REQUEST

Current Zoning: I-2 (general industrial) and TOD-M (transit oriented development - mixed-use)
Proposed Zoning: TOD-M(O) (transit oriented development - mixed-use, optional)

SUMMARY OF PETITION

The petition proposes to allow the redevelopment of a full block of commercial buildings and surface parking for all uses in the TOD-M (transit oriented development – mixed-use district).

• Proposed Request Details

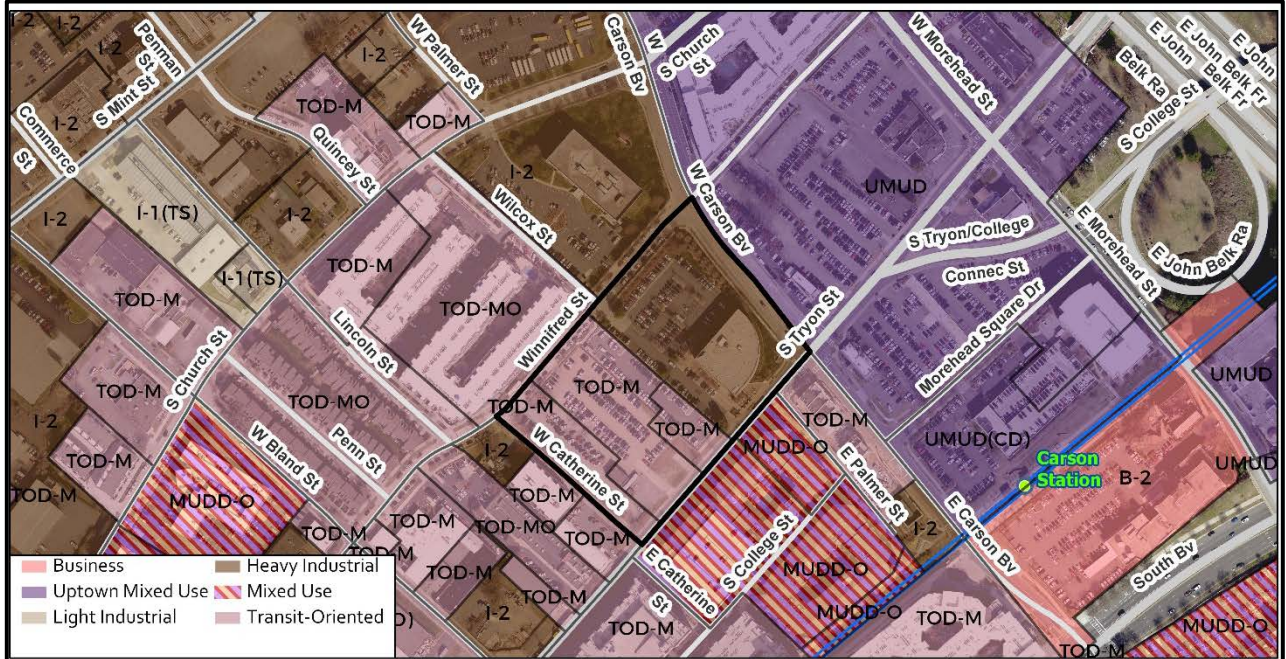
- ~~1. Remove the optional request for the increased ground mounted sign.~~ Addressed
- ~~2. Provide a definition or examples of visual delineation as mention in the architectural standards.~~ Addressed
- ~~3. Under Architectural notes modify note a2 to "shall be taller than it is wide".~~ Addressed
- ~~4. Under Architectural notes modify note a3 to "elements "shall help create this effect".~~ Addressed
- ~~5. Under Façade & Material Detailing modify note 3 to "durable finish materials shall be used on the first floor street façade of buildings".~~ Addressed
- ~~6. Under Façade & Material Detailing modify note 4 to "store front windows shall have intermediate piers".~~ Addressed
